Delegated officer report for planning application

Application no.	143805/AO/2025
Date registered valid:	11 September 2025
Proposal:	Installation of no.2 externally illuminated hanging signs
Address:	Kings House, Sidney Street, Manchester, M1 7HB
Ward(s):	Hulme Ward
Applicant:	Mr Michael Burke Kings Church
Agent (if any):	
Case officer:	Sam Elliott Tel: 0161 219 2856 Email: sam.elliott@manchester.gov.uk
Recommendation:	Refuse
Date of recommendation:	04/11/2025

(Figures 3-4: Proposed Sign Panel and Bracket)

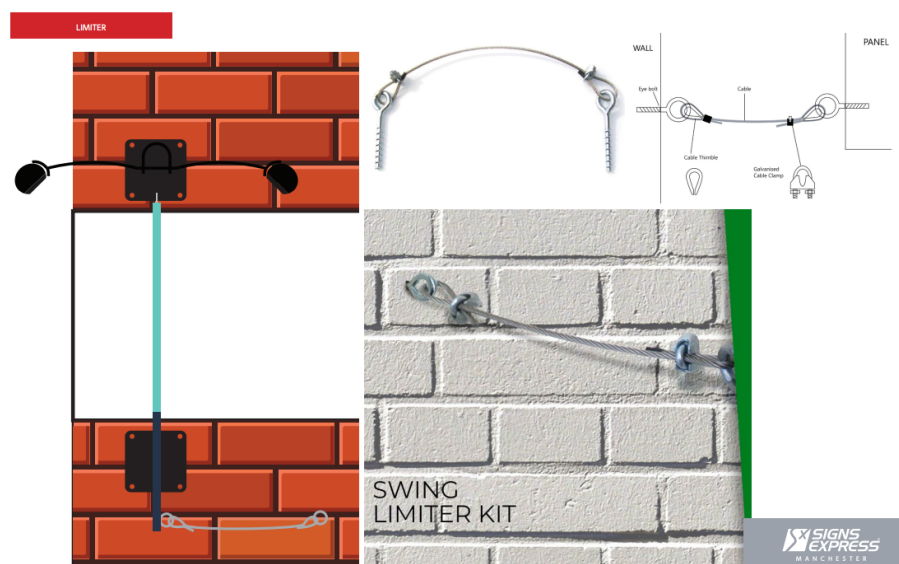
The signs would each hang from a large steel bracket, projecting a maximum of 1055mm from the building's elevation and formed by parallel rods in an 'L' shape. The bracket would be powder coated black in RAL 9005. They would be affixed at both ends of the elevation at fascia level, with the 150mm x 150 mm fixing plates straddling the building's white concrete lintel.

However, the proposed signage comprises a number of disparate design elements that ultimately appear discordant to the detriment of the building and street scene. Each sign panel would be a PCV board with a vinyl print with a 30mm depth. The bracket would be comprised of multiple relatively large and right-angled rods in black powder coating, with a 'heavy duty' appearance that has a prominent visual impact on the building. The 2no. fixing plates per sign would also each be relatively large, measuring 150mm x 150mm and also in black. Taken in isolation, the brackets of these dimensions, bulk and colour would be considered acceptable, with some design quality to the structure. In the context of the bracket design, the sign panels while not of the highest design quality have a sleek form with a 30mm depth and only contain information pertinent to identifying the premises, in line with the Council's Shopfront and Signage Design Guide and therefore acceptable on balance.

(Figure 5: Proposed Swing Limiter)

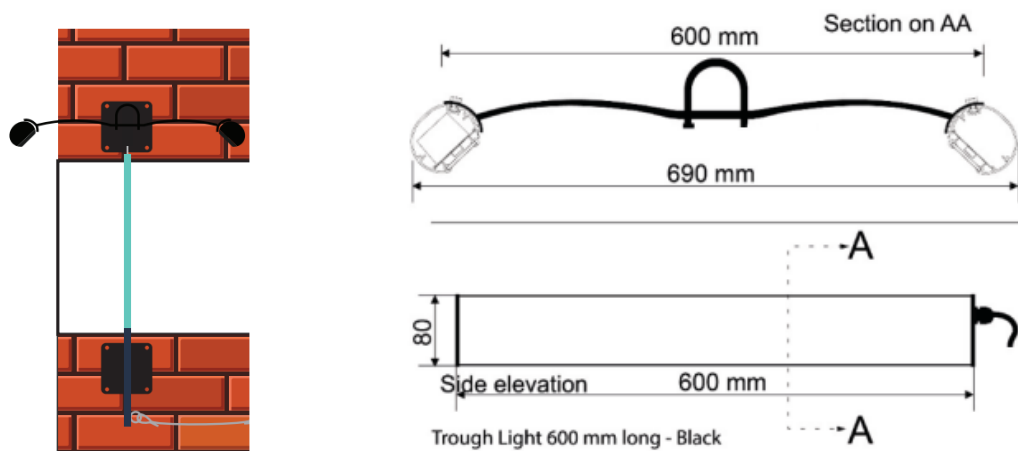
A swing limiter would be affixed to the bottom of each sign panel to secure the sign into the brickwork via bolts and cable clamps. The applicant has not provided details clarifying the number of clamps required.

However, when seen in conjunction with the external lighting rig and swing limiter it is considered that the cumulative impact would be that of an overly cluttered, unintegrated and low-quality final product. It is not clear how the external lighting rig would be combined to the bracket, and the applicant has not provided sufficient information on how this is to be achieved. Notwithstanding this, the rig features much thinner rods that are curved, integrating poorly with the thicker and angular bracket frame. It would moreover feature large, rounded trough lights that add a further degree of bulk to the already bulky rectangular frame.

(Figures 10-11: Product information provided by applicant 21/10/2025 for bracket and externally mounted lighting rig, proposed to be combined)

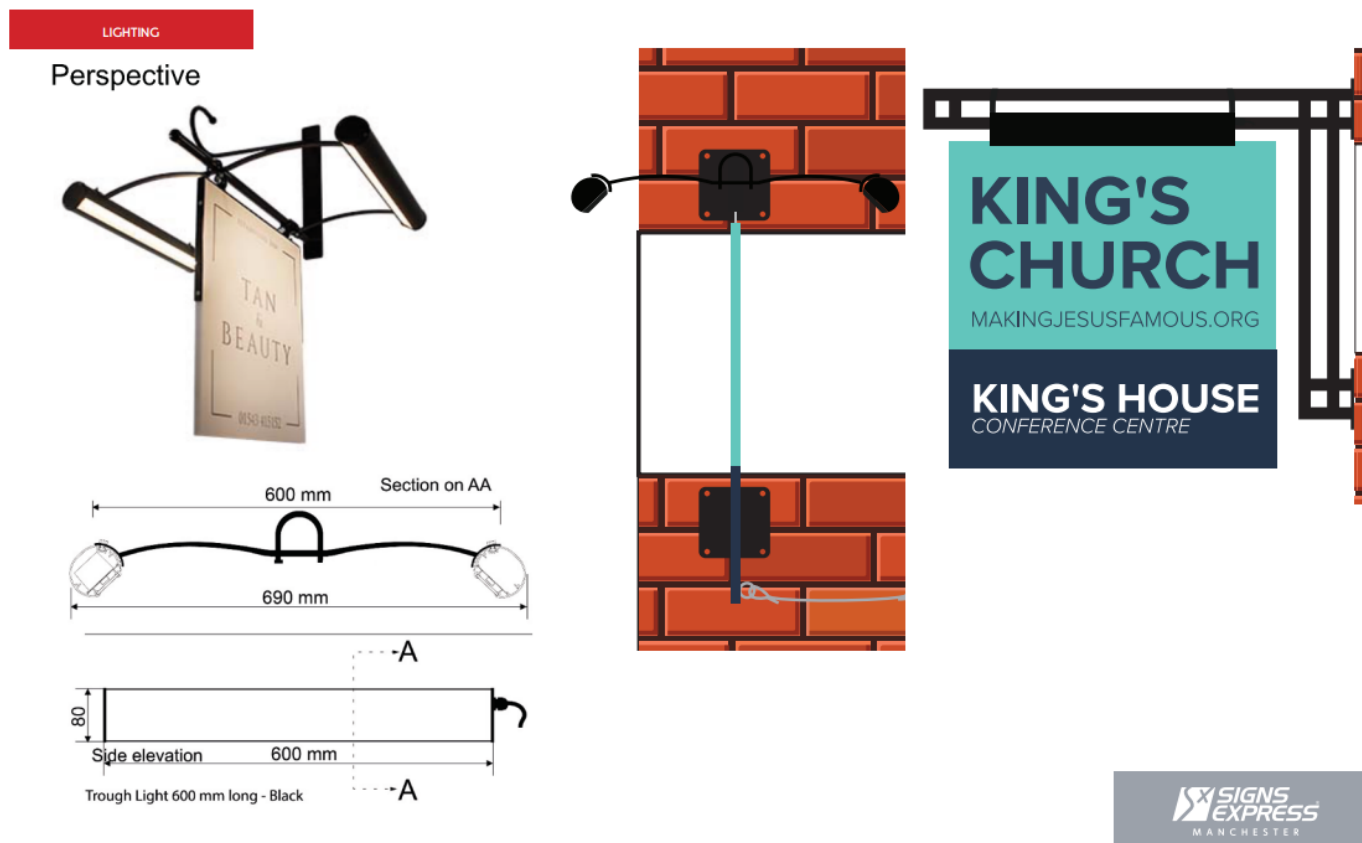
It is considered that the curved frame of the external lighting rig would not correspond to the blocky, angular and heavy-duty form of the bracket, and that the large trough lights introduce a further disparate element to the design while also adding an unacceptable degree of bulk to the products' profile. With the addition of the swing limiters requiring additional bolting into the elevation as well as an undetermined number of clamps fixed into the brickwork, the 2no. hanging signs would appear overly cluttered and discordant to the detriment of the facade.
